Addendum #1

Project: Madison Utility Improvements – Garfield Avenue S. & S. Highland Ave. - 2017

Issue Date: March 10, 2017

PROJECT / SHEET TITLE:
UTILITY IMPROVEMENTS - GARFIELD AVE. S. & S. HIGHLAND AVE. - 2017
HIGHLAND AVE. WATER MAIN BORE PLAN & PROFILE

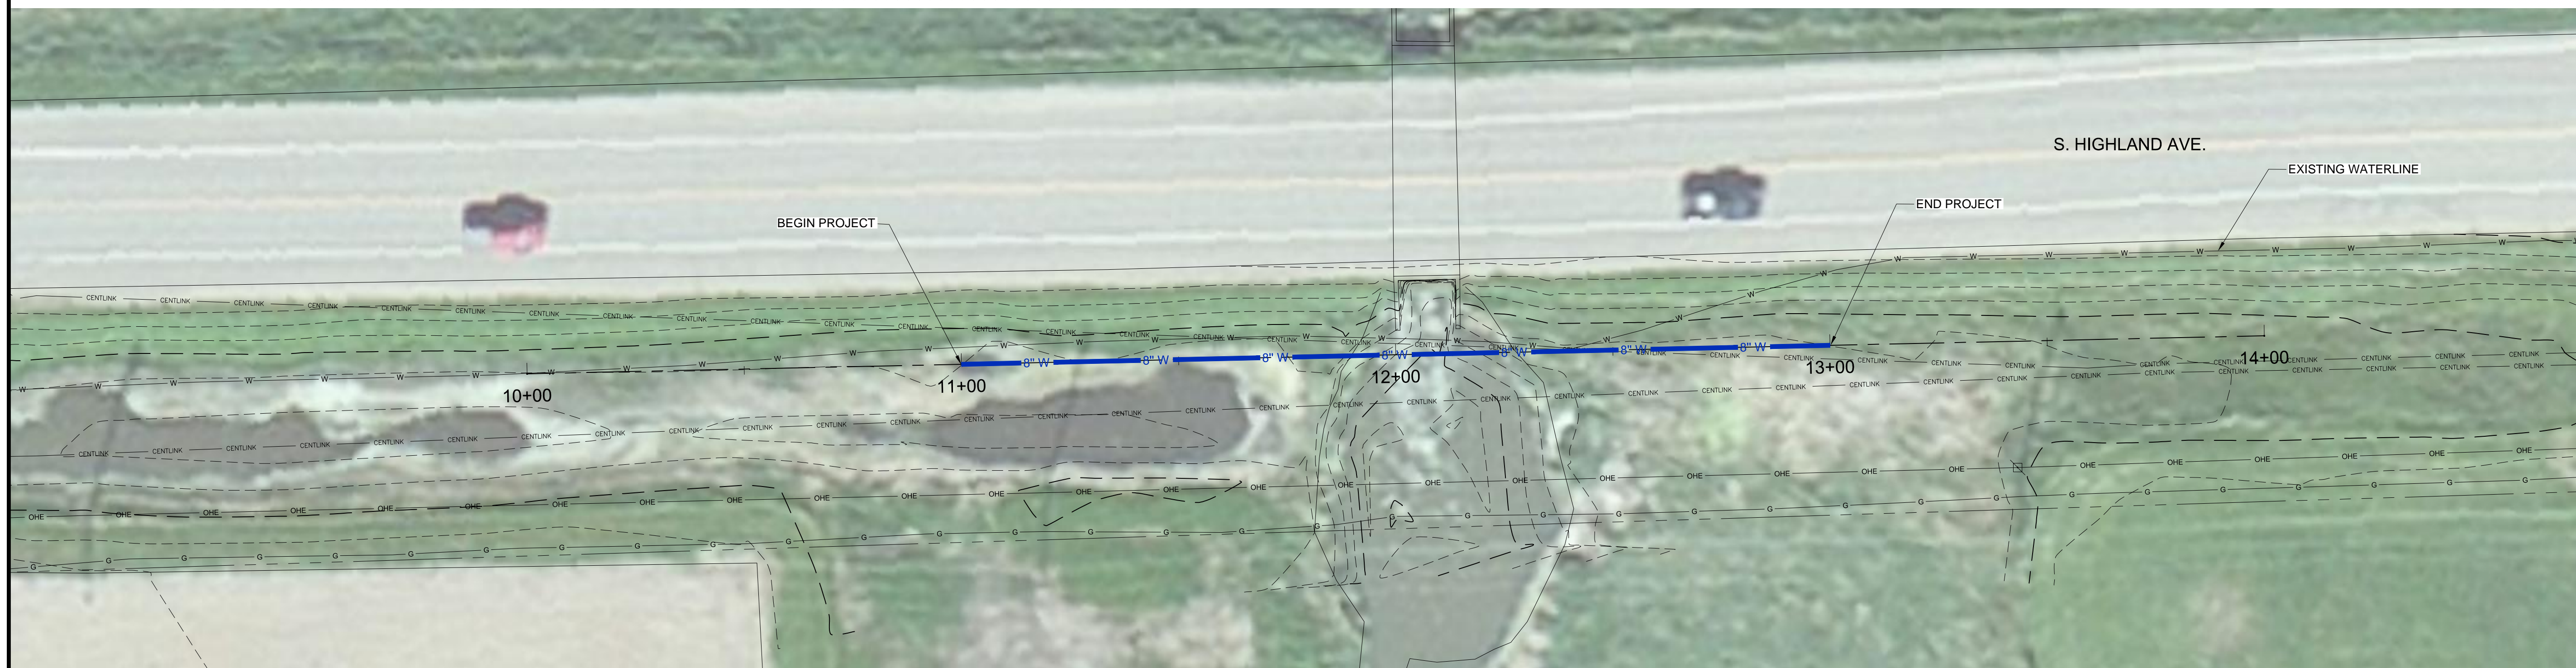
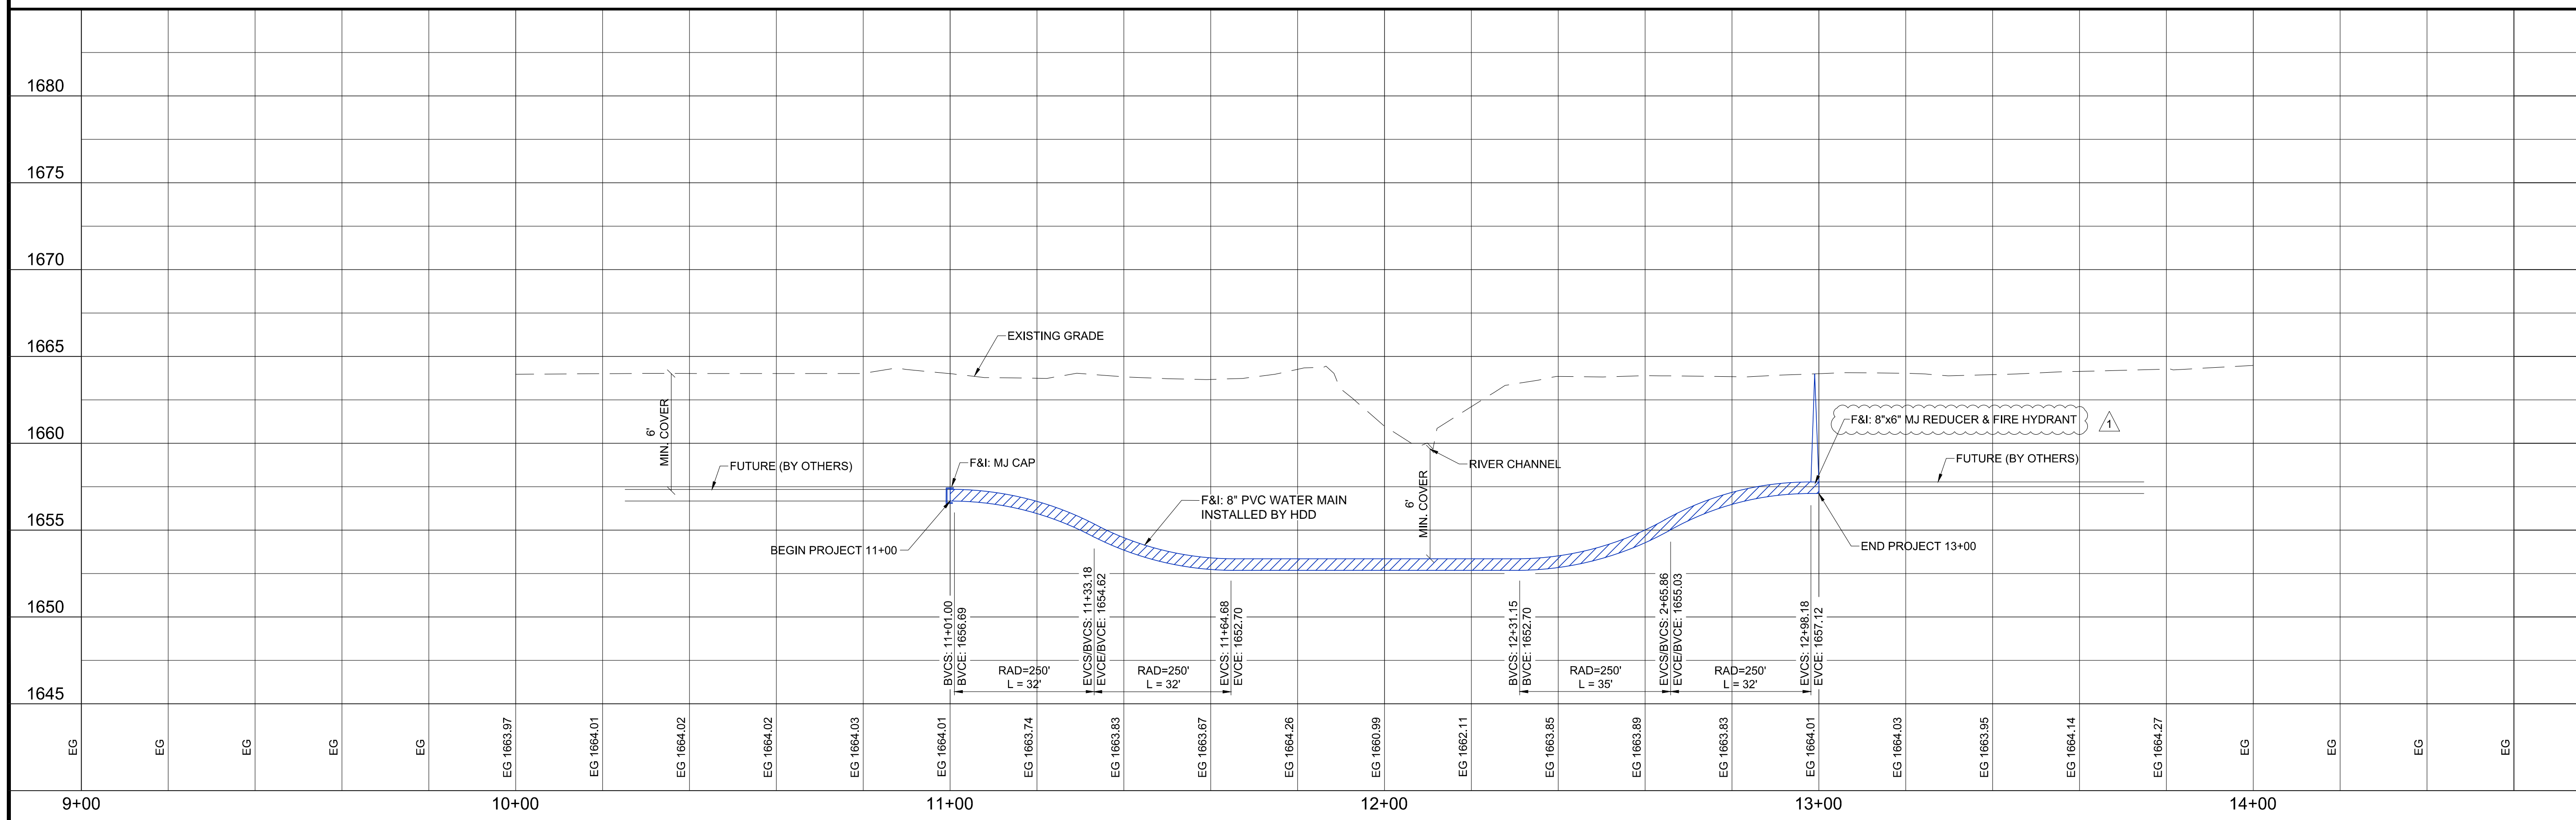
All references to temporary hydrant shall be deleted. The fire hydrant that the contractor will use shall be new and remain in place at the conclusion of the project. See attached Plan Sheet 8.

WATER STA. 13+00
FURNISH & INSTALL:
1 EA - 8" x 6" MJ REDUCER
1 EA - FIRE HYDRANT

DESCRIPTION
FIRE HYDRANT
